GROUND FLOOR LAYOUT - PROPOSED INTRUSIVE INVESTIGATIONS

Job	Neptune Mill			Date	01.09.23
Title	Proposed Intrusive Investigations			Eng.	SD
Job No.	2909	Sheet	SK-230405-01	Rev.	P2

HEYNE TILLETT STEEL

FIRST FLOOR LAYOUT - PROPOSED INTRUSIVE INVESTIGATIONS

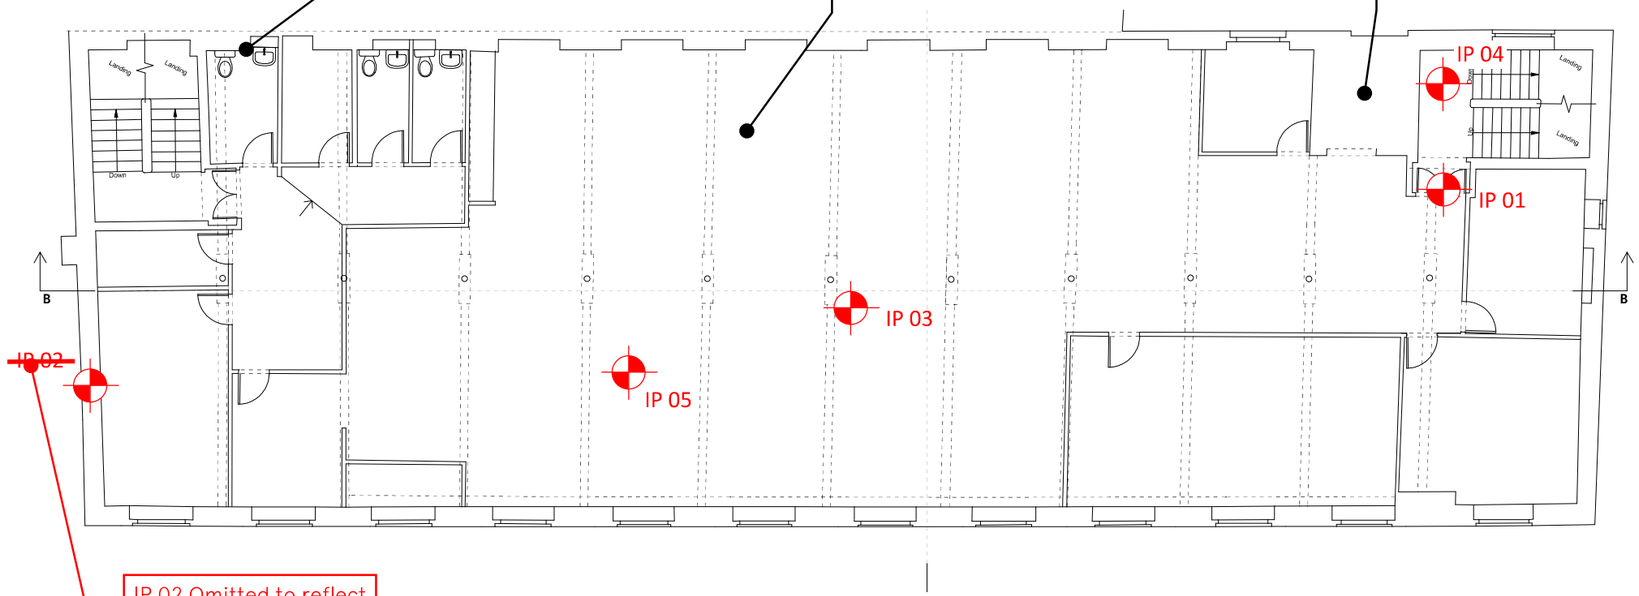
IP 02 Omitted to reflect change in scope.

~~IP 02~~ - ~~Establish thickness and build up of existing wall subject to proposed alterations. Local removal of finishes / brickwork / pilot hole required.~~

IP 02 Omitted to reflect change in scope.

SECOND FLOOR LAYOUT - PROPOSED INTRUSIVE INVESTIGATIONS

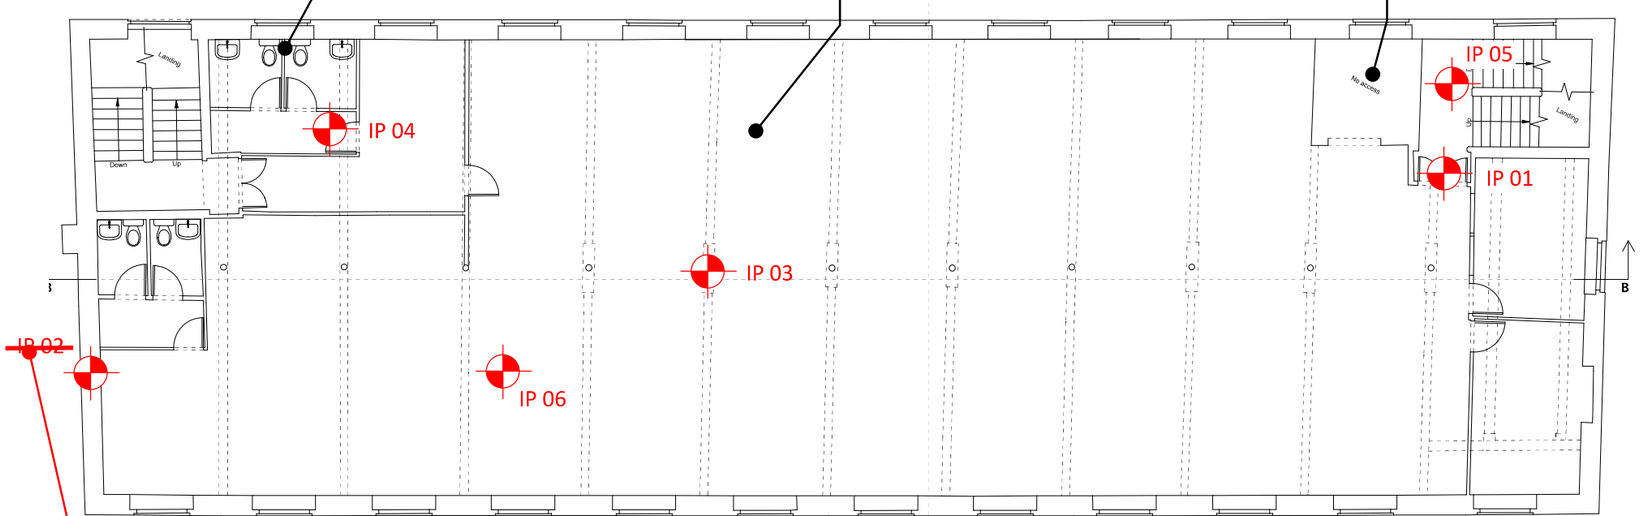
IP 02 Omitted to reflect change in scope.

~~**IP 02 -** Establish thickness and build up of existing wall subject to proposed alterations. Local removal of finishes / brickwork / pilot hole required.~~

IP 02 Omitted to reflect change in scope.

THIRD FLOOR LAYOUT - PROPOSED INTRUSIVE INVESTIGATIONS

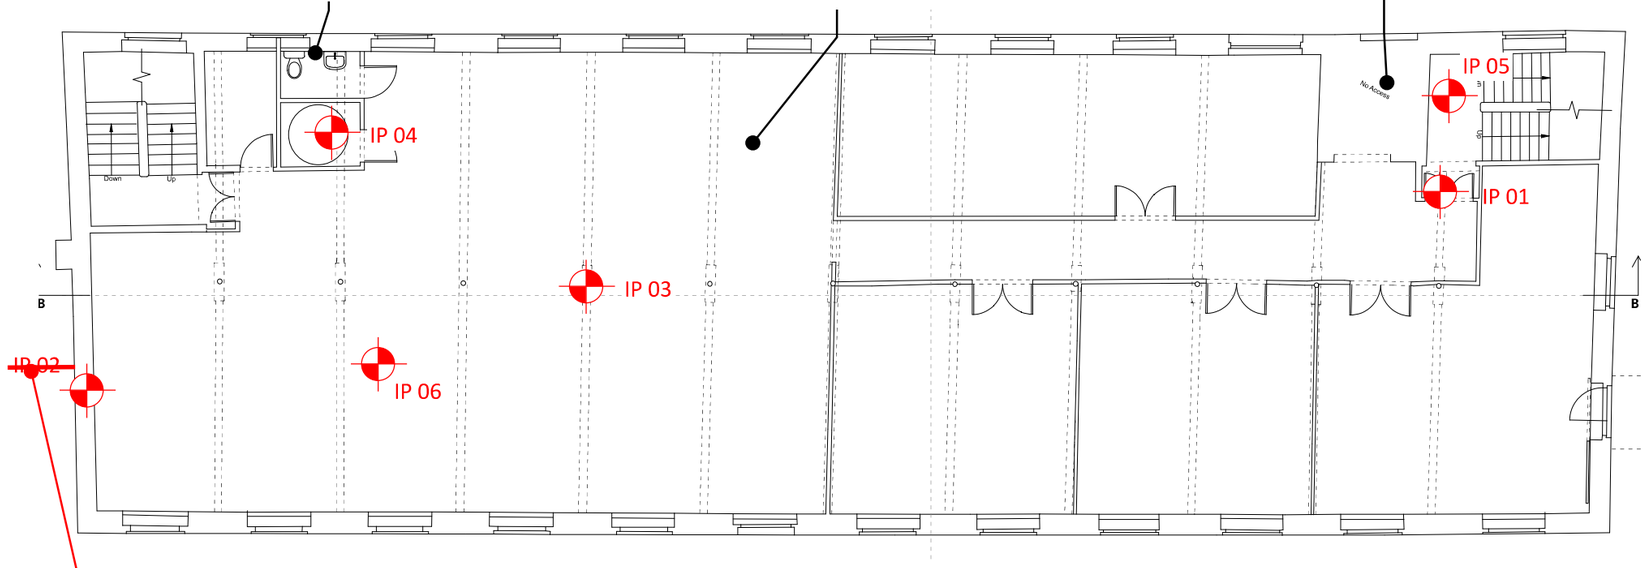
IP 02 Omitted to reflect change in scope.

~~**IP 02** – Establish thickness and build up of existing wall subject to proposed alterations. Local removal of finishes / brickwork / pilot hole required.~~

IP 02 Omitted to reflect change in scope.

FOURTH FLOOR LAYOUT - PROPOSED INTRUSIVE INVESTIGATIONS

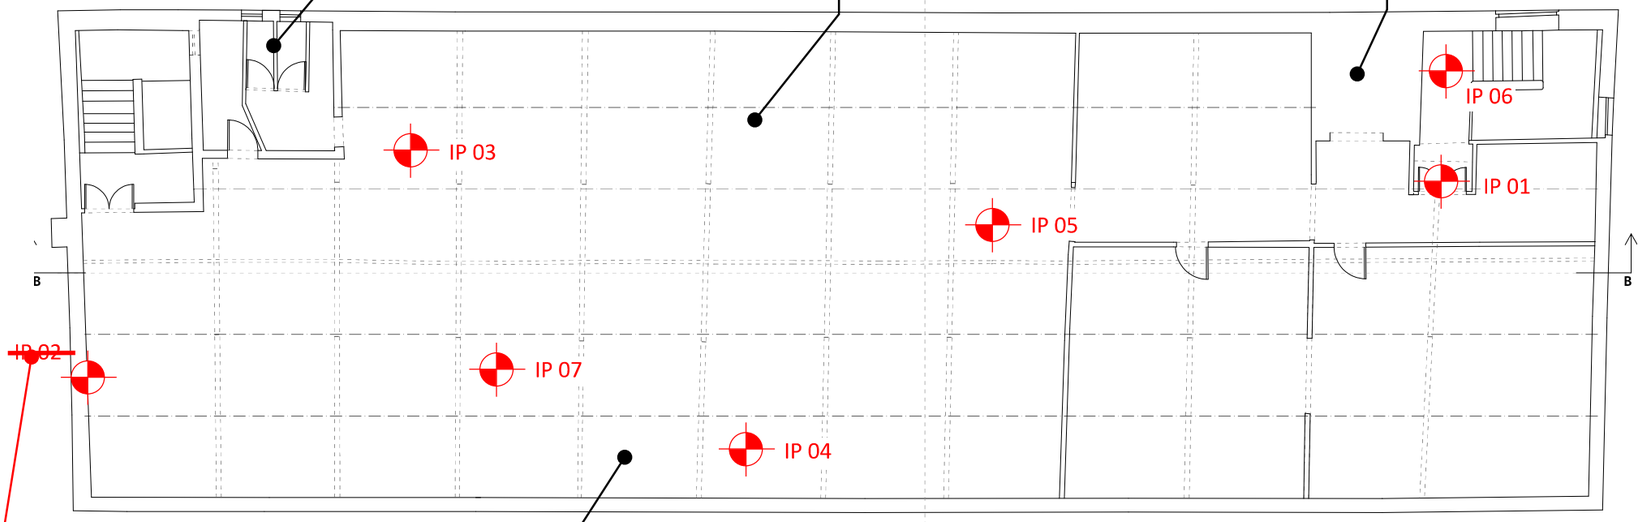
IP 02 Omitted to reflect change in scope.

~~**IP 02** - Establish thickness and build up of existing wall subject to proposed alterations. Local removal of finishes / brickwork / pilot hole required.~~

IP 02 Omitted to reflect change in scope.
